SERVICE RECEIVED LETTER

No. 564

Subject: Revised Hartzell Propellers

Service Letter No. 62

Instructions for Installation:

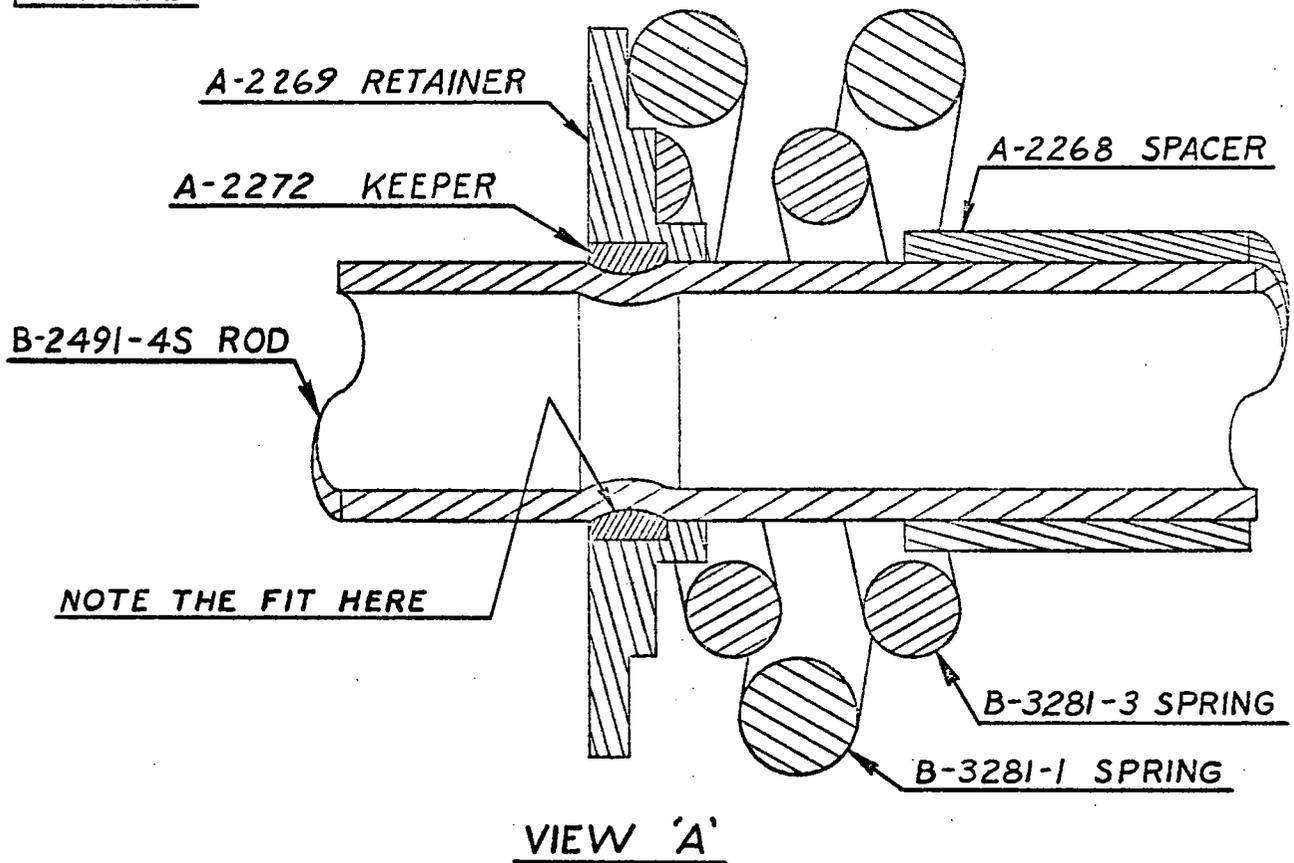
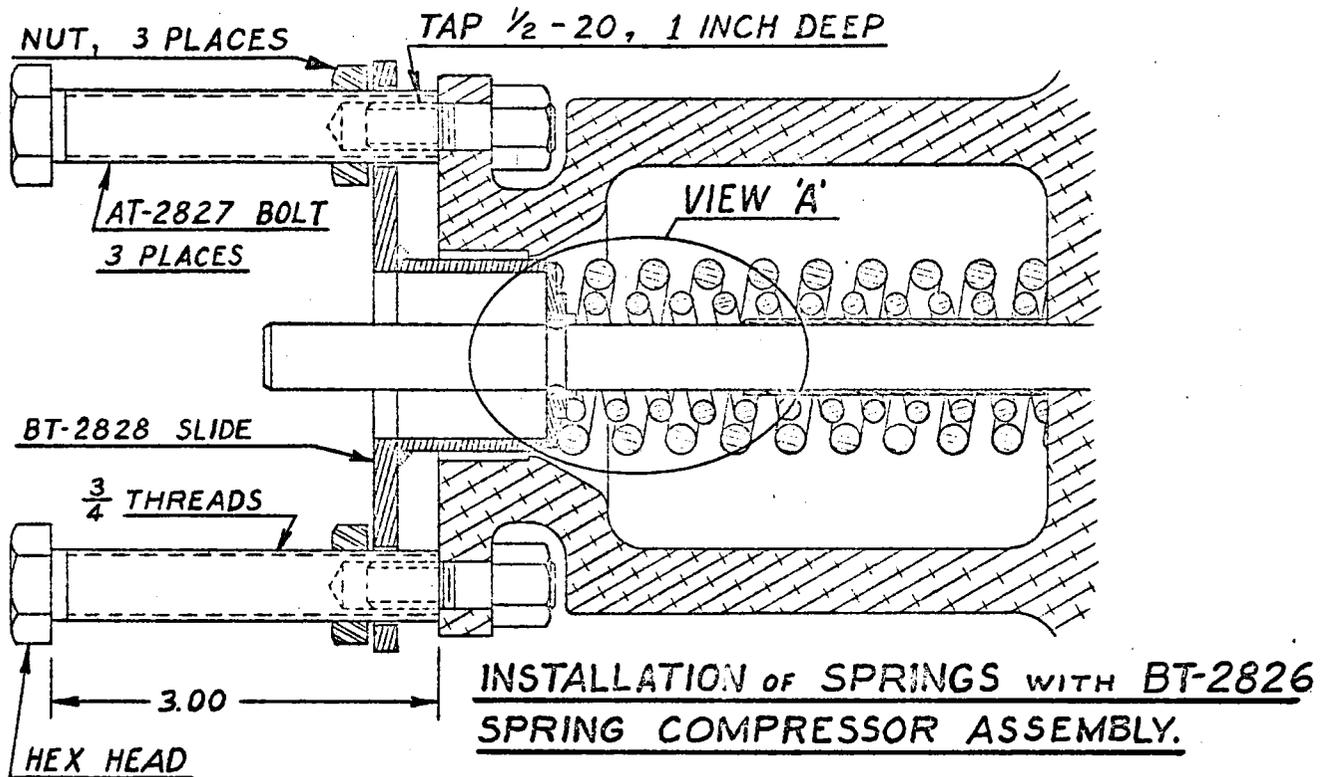
- 4) Install the spring kit in the extension shaft cavity, as shown in the following sketch, as follows:
 - (a) install A-2268 spacer on the B-2491-4S rod
 - (b) install the B-3281-1 and -3 springs over the spacer
 - (c) install the A-2269 retainer as shown
 - (d) compress the springs with special spring compressor, P/N BT-2826
 - (e) install A-2272 keeper in the groove formed in the B-2491-4S rod, as shown in the enlarged sketch
 - (f) remove spring compressor, allowing the springs to bear against the A-2269 retainer
- 5) Unfeather the blades with pressure applied through B-2491-4S rod, or by means of blade arms applied to both blades.
- 6) Recharge the cylinder with dry air or nitrogen to:
